Requests for Additional Information - PANDA RAIs

ESBWR NRC Meeting
Closed Session
June 25, 2003
Rockville, Maryland

Test P4&5

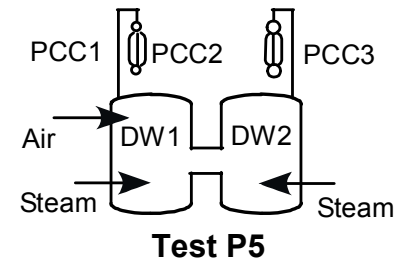
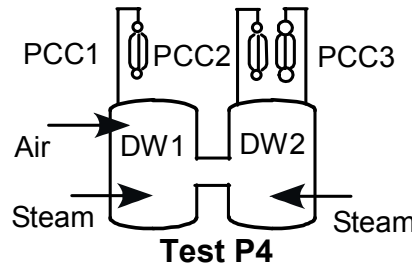
Would not a slow release (order of 1% or less) of noncondensibles be a better test of delayed release ?

Test P6

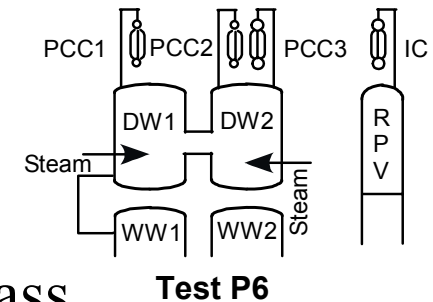
Why combine IC operation and steam bypass

Why does WW-DW press diff decrease slower than in P1/8

Why do the PCCs still work when WW-DW $\Delta p = 0$

Press diff blip at 42,000 s

Over-prediction of VB flow between 15,000-25,000s
